A585 Windy Harbour to Skippool Improvement Scheme

7.11 Environmental Statement Changes and Corrections Document

May 2019

Project: A585 WINDY HARBOUR TO SKIPPOOL IMPROVEMENT SCHEME
 Drawing Title: ENVIRONMENTAL STATEMENT REGULATION 5(2)(a) NOISE AND VIBRATION: NOISE MITIGATION SHEET 1 OF 6

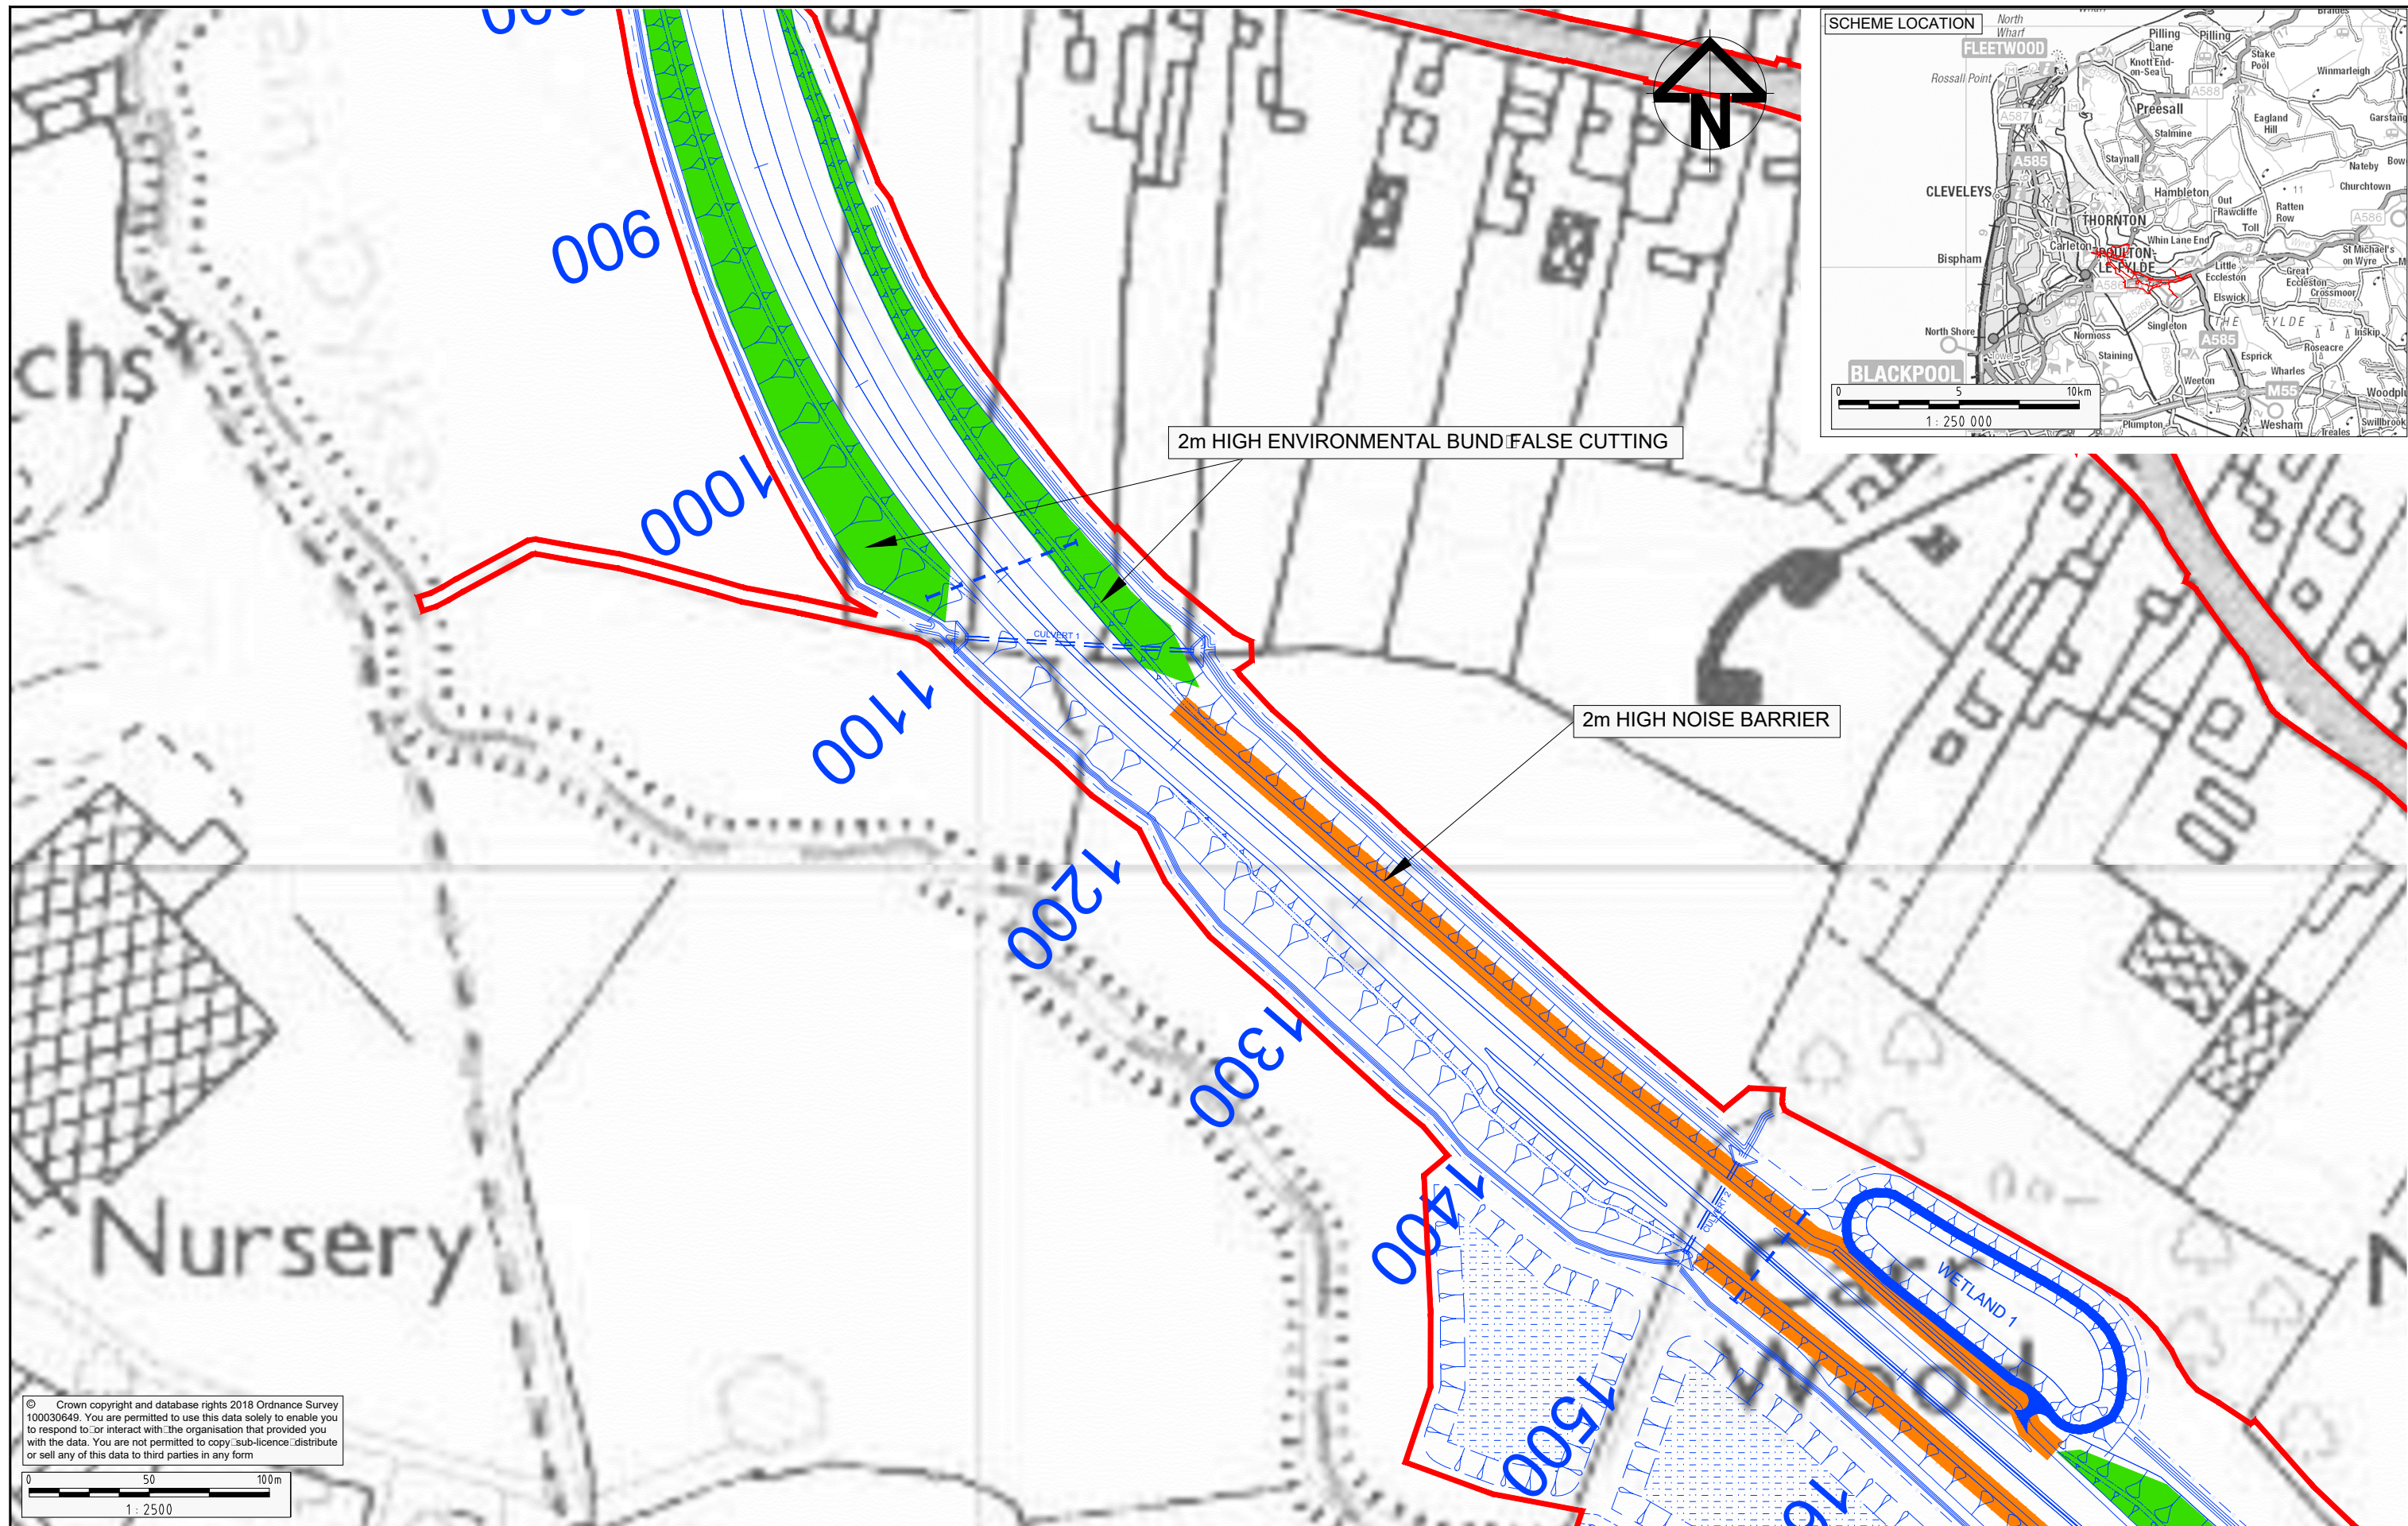
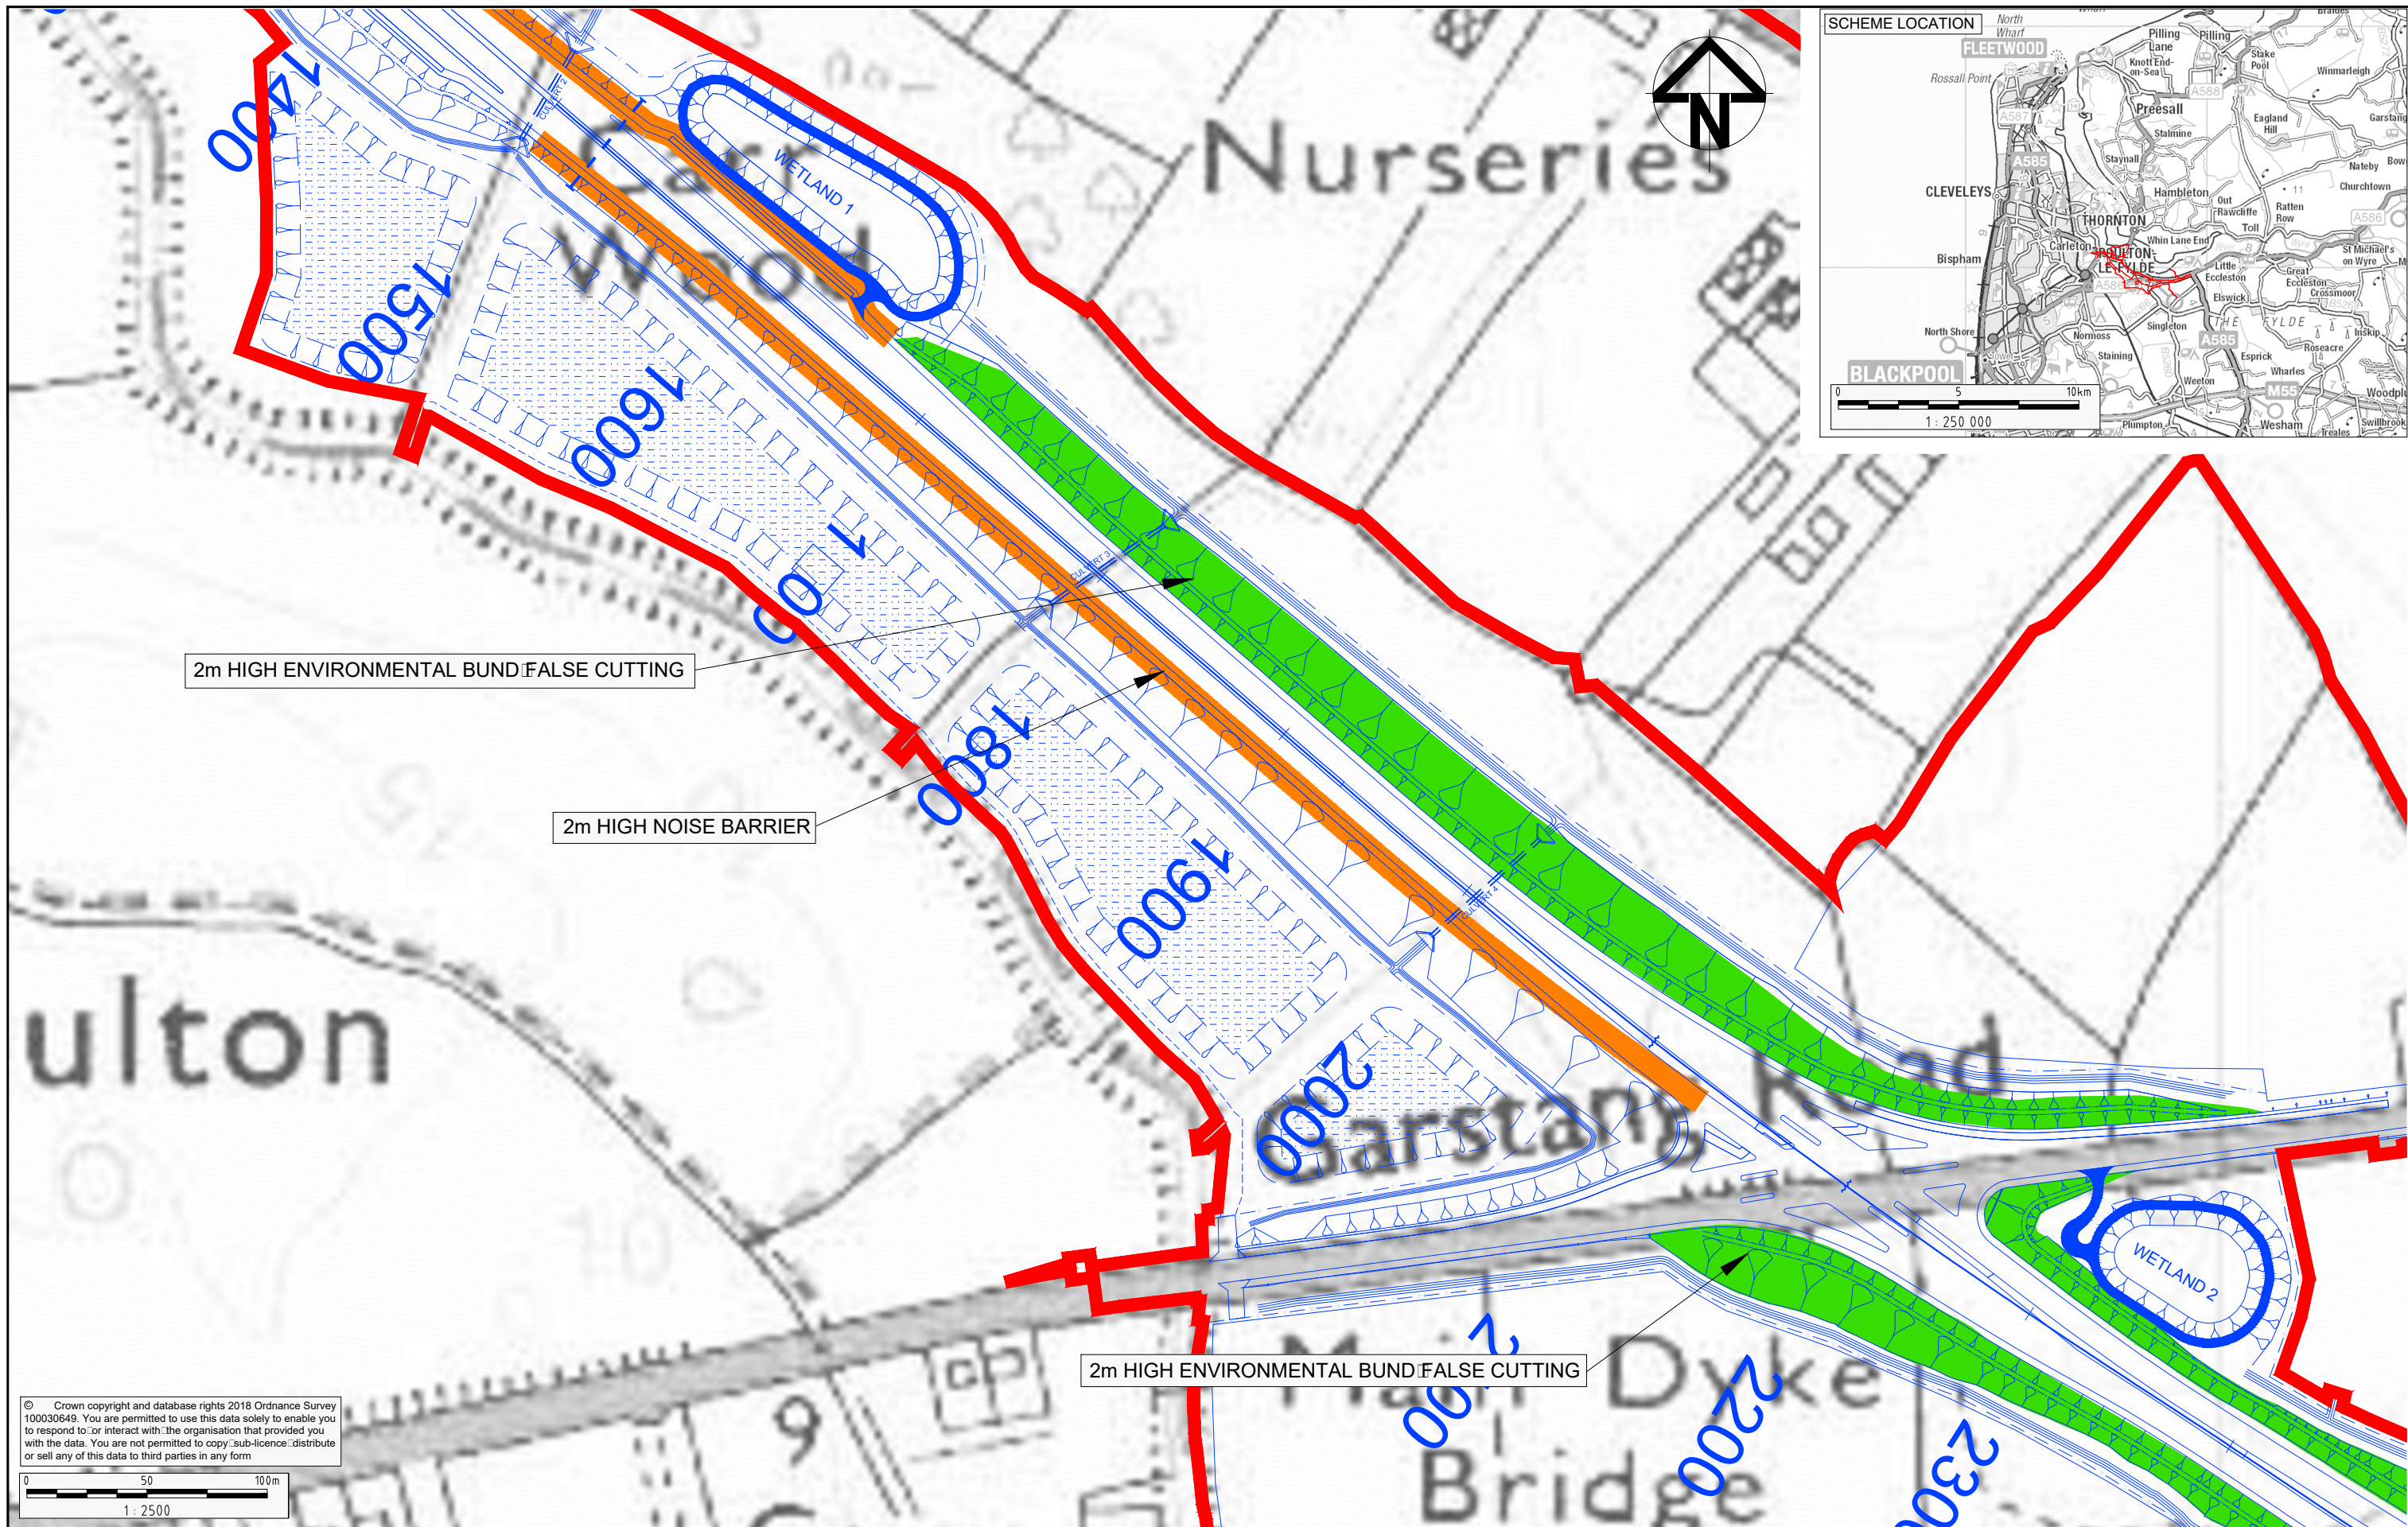
6.11	ES Chapter 11: Noise and Vibration	Update to Figure 11.4: Noise and Vibration – Noise Mitigation within the Study Area presented at Appendix D to show heights and locations of earth mounds and acoustic fencing at a larger scale.	Requested by the Inspector within the first round of written questions (document reference TR010035/APP/7.10).
